PIC18F45J10 Family Silicon Errata and Data Sheet Clarification

The PIC18F45J10 family devices that you have received conform functionally to the current Device Data Sheet (DS39682E), except for the anomalies described in this document.

The following typographic corrections and clarifications are to be noted for the latest version of the device data sheet (DS39682E):

FIGURE 2-3 FREQUENCY vs. ESR PERFORMANCE FOR SUGGESTED VCAP

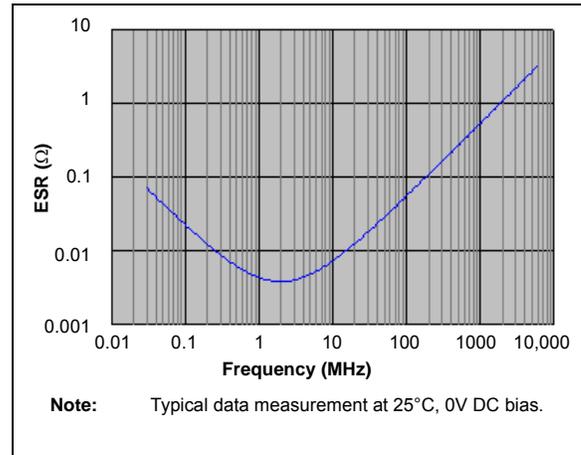
Section 2.4 Voltage Regulator Pins (VCAP/VDDCORE) has been replaced with a new and more detailed section. The entire text follows:

Designers may use [Figure 2-3](#) to evaluate ESR equivalence of candidate devices.

When the regulator is enabled (F devices), a low-ESR (< 5Ω) capacitor is required on the VCAP/VDDCORE pin to stabilize the voltage regulator output voltage. The VCAP/VDDCORE pin must not be connected to VDD and must use a capacitor of 10 μF connected to ground. The type can be ceramic or tantalum. Suitable examples of capacitors are shown in [Table 2-1](#). Capacitors with equivalent specifications can be used.

FIGURE 2-4 DC BIAS VOLTAGE vs. CAPACITANCE CHARACTERISTICS

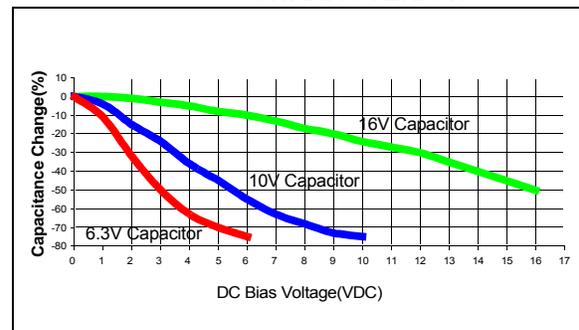
In addition to temperature tolerance, the effective capacitance of large value ceramic capacitors can vary substantially, based on the amount of DC voltage applied to the capacitor. This effect can be very significant, but is often overlooked or is not always documented.

A typical DC bias voltage vs. capacitance graph for 16V, 10V and 6.3V rated capacitors is shown in Figure 2-4.

When selecting a ceramic capacitor to be used with the internal voltage regulator, it is suggested to select a high-voltage rating, so that the operating voltage is a small percentage of the maximum rated capacitor voltage. For example, choose a ceramic capacitor rated at 16V for the 2.5V core voltage. Suggested capacitors are shown in Table 2-1.
